**Department of Planning
and Development**
700 5th Avenue, Suite 2000
PO Box 34019
Seattle, WA 98124-4019

Project Description

The applicant is proposing a 34 story, mixed use project on the block bounded by University Street, 1st Avenue, Seneca Street, and 2nd Avenue. The petitioner plans to develop the project on three-fourths of the block, with the remaining portion of the block, which is currently occupied by the historic Diller Hotel, to remain. The project assumes a partial alley vacation, with 2,560 square feet to be vacated and 1,280 square feet to remain.

October 15, 2015
9:00 - 10:30 am

Figure 5: Circulation - no vacation (left) and vacation (right) scenarios

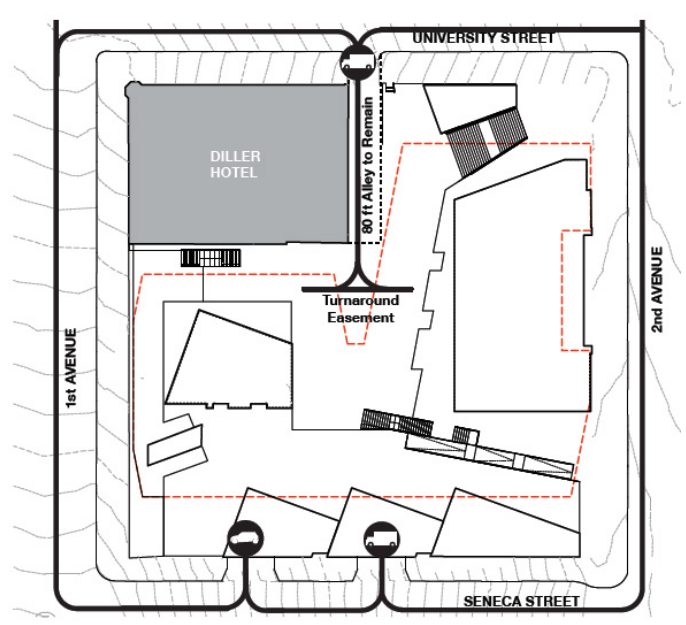
access for the largest service vehicle that able to access the hammerhead through the partial alley. Ms. Watson also stated that she is concerned that the hammerhead overlays with the area where pedestrians are walking along 1st Avenue. She not only questions how truck drivers will know when and where to turn around safely, but also how pedestrians will know where to walk when loading vehicles are moving through space.

The commission supported the hammerhead design that will serve both the Diller Hotel and provide additional pedestrian plaza area. Commissioners requested that the team continue researching how vehicular access along the portion of the non-vacated alley will be managed during the daytime hours.

- The proposed pedestrian access points along 1st Ave should be redesigned to reinforce their role as access to and through the site, increasing their visibility and presence along 1st Ave
- Provide a conceptual landscape plan for the site. As part of this plan, please include information on how the ground plane will be treated and how planting will reinforce pedestrian routes in and through the site
- Provide additional details about the hammerhead design. Your designs should show how the hammerhead relates to alley function, how pedestrian movement will be accommodated and how it reinforces the open space network

Figure 6: Access - no vacation (left) and vacation (right) scenarios

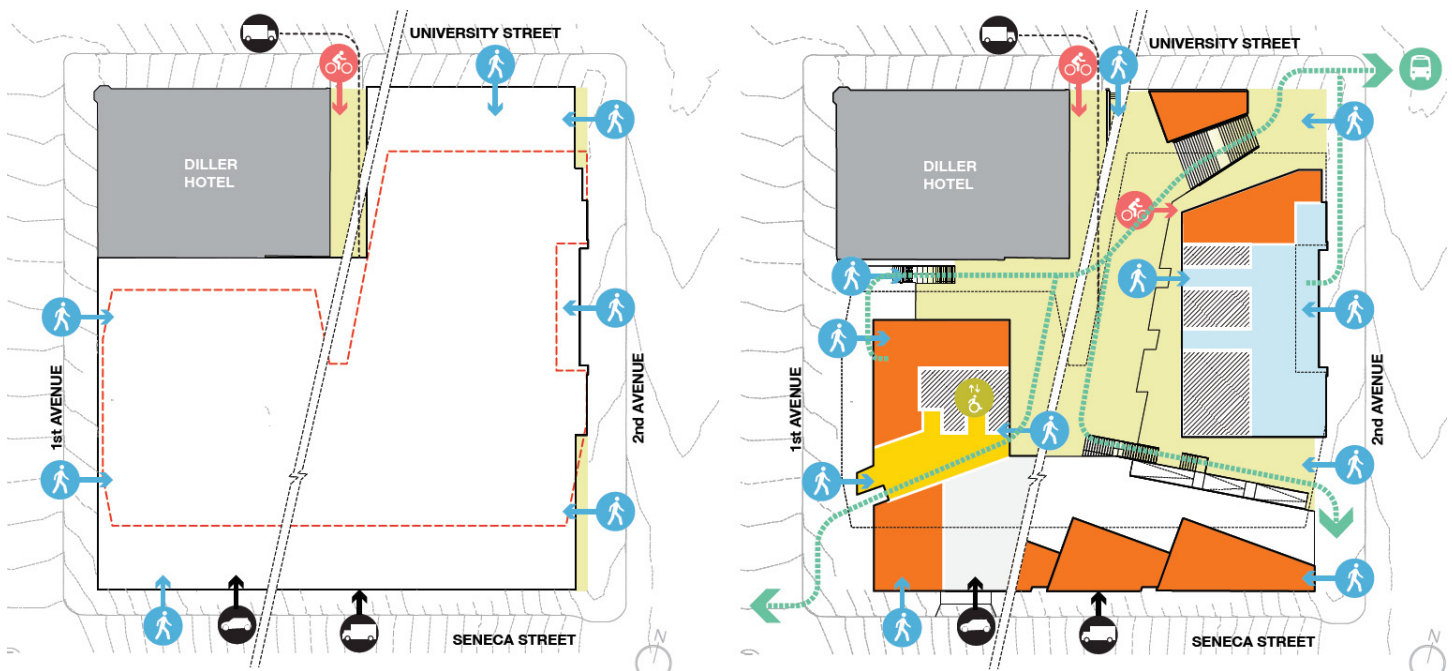
Ms. Watson is also concerned with accessibility to the designed public space. More specifically, she is concerned with access to and from 1st Avenue, which is expected to increase in pedestrian volume once the 1st Avenue Streetcar line is finished. The current design plan includes publicly open space that is 13' above 1st Avenue street level, which will only be accessible by using a narrow stairway. Ms. Watson would like the design team to think about creating an entrance along 1st Avenue that is more welcoming to pedestrians.

Although the Commission supported the lifting of the building to allow light and views throughout the public space, they are concerned with the level of accessibility throughout the space. Commissioners encouraged the design team to focus on creating entrances that are visible and inviting to the public, especially along the corner of 1st Avenue and Seneca Street. The commission would like the design team to consider creating visible pathways throughout the plaza that connect to the streets surrounding the site. Commissioners also encouraged the design team to use more landscaping to invite pedestrians into the public space.

Figure 7: Light - no vacation (left) and vacation (right) scenarios

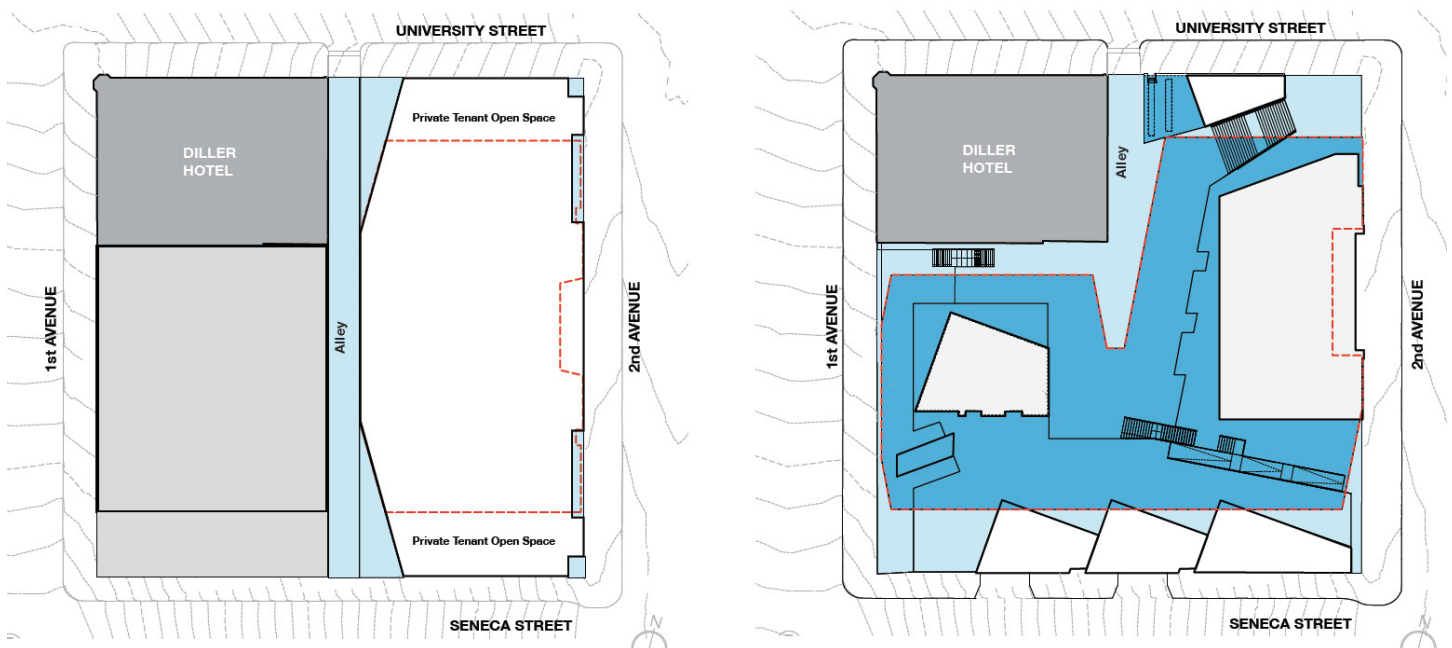
The Commission appreciates the design team's attempt to bring light and air into the open space under the building by maximizing how much the building was lifted above grade. Commissioners encouraged the design team to think about how lighting within the open space can be used to create a level of comfort during the day, evening, and night hours.

- Incorporate a lighting design to highlight events occurring during the late afternoon and evening within the interior of the site
- Provide and illustrate a stronger sense of permeability through the loading dock as an access corridor into the plaza from Seneca
- The design team emphasize the service vehicle loading area as an active pedestrian space
- Work with SPU to better understand the placement of the utility bulbs so they don't conflict with public accessibility
- Use caution with the notion urban village; don't confuse it with the land use code definition
- Developing the open space under the building to be open and accessible to the general public
